ADDENDUM NO. 1

**TO SPECIFICATIONS AND PLANS FOR THE
CITY OF TRAVERSE CITY**

2026 Paving and Resurfacing Project

ISSUED: January 29, 2026

Revision/Issue	Date
ADDENDUM #1	1-29-26
Date:	12-17-2025
Project No.:	2026-005
Drawn by:	JAS
Scale:	1" = 5'
Sheet No.:	37 OF 38

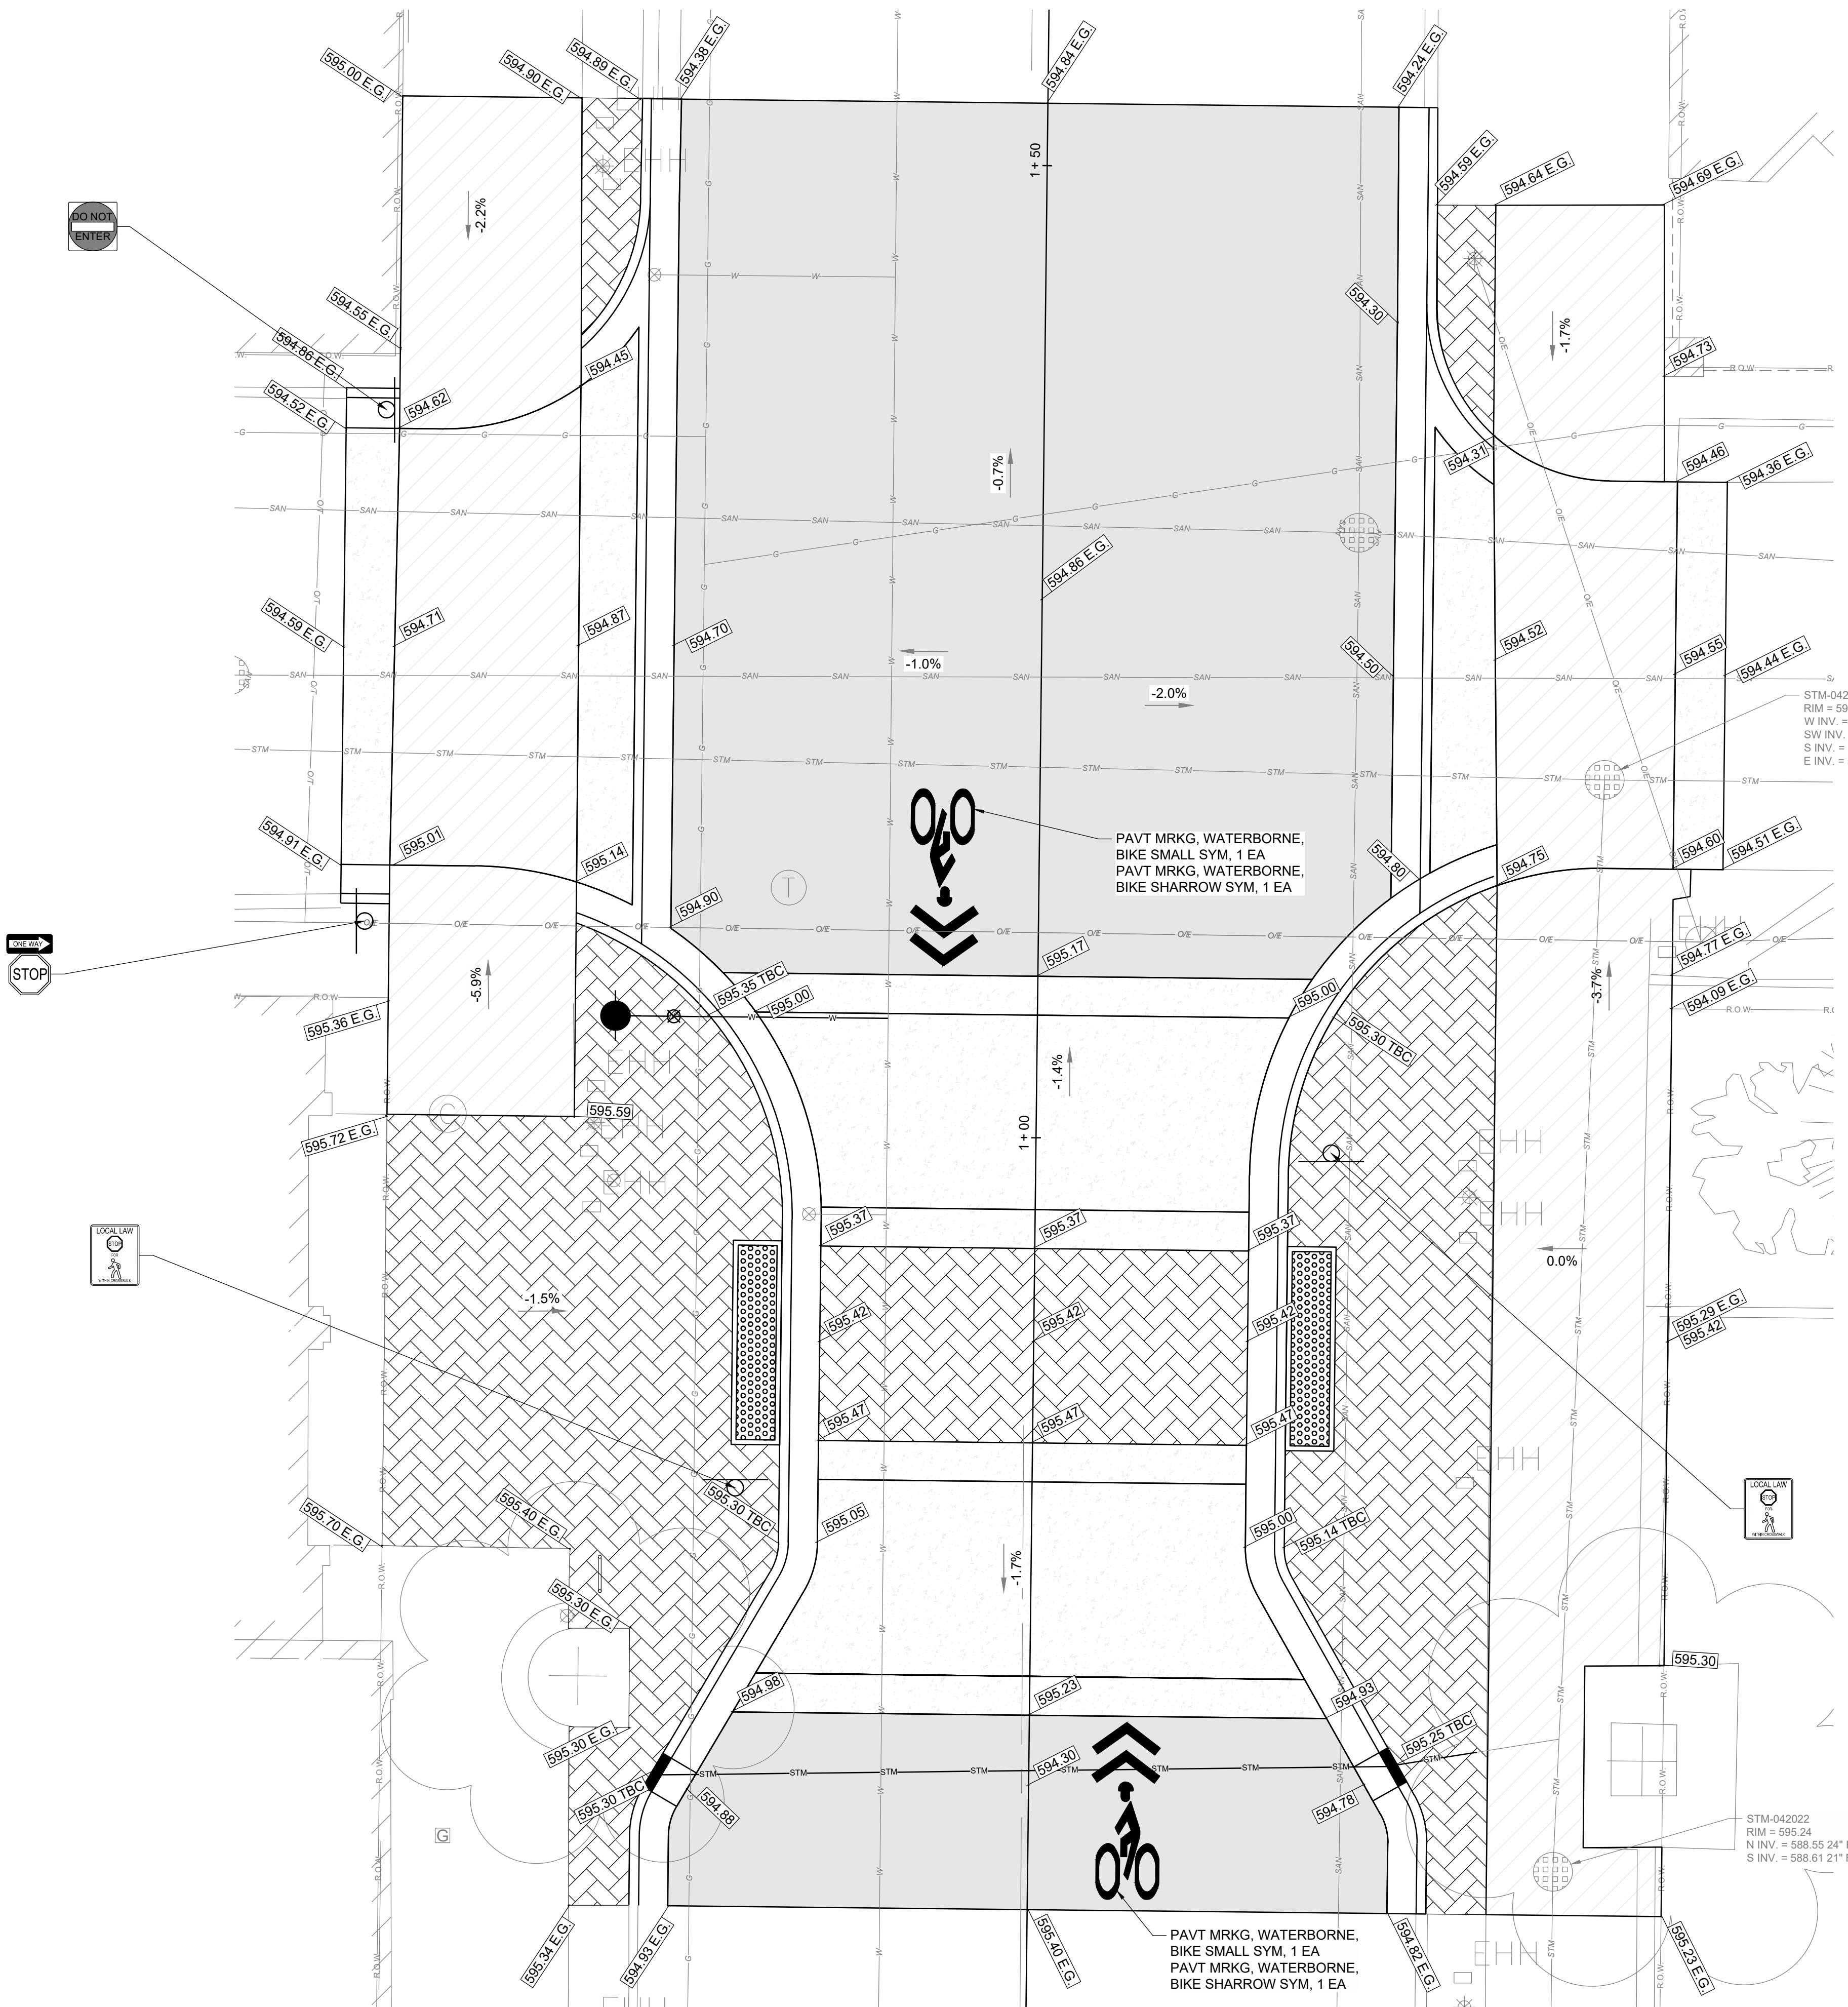
1. Revision to the plans on sheet 37. The plan sheet included in this Addendum shall replace the corresponding plan sheet in the original bid set:
 - a. Pay item Sign, Type IIIA was added in the quantity box.
 - b. Pay item Sign, Type IIIB was edited in the quantity box.
 - c. Sign, Type IIIA quantity was edited to 7 Sft.

d. Sign, Type IIIB quantity was edited to 20 Sft.
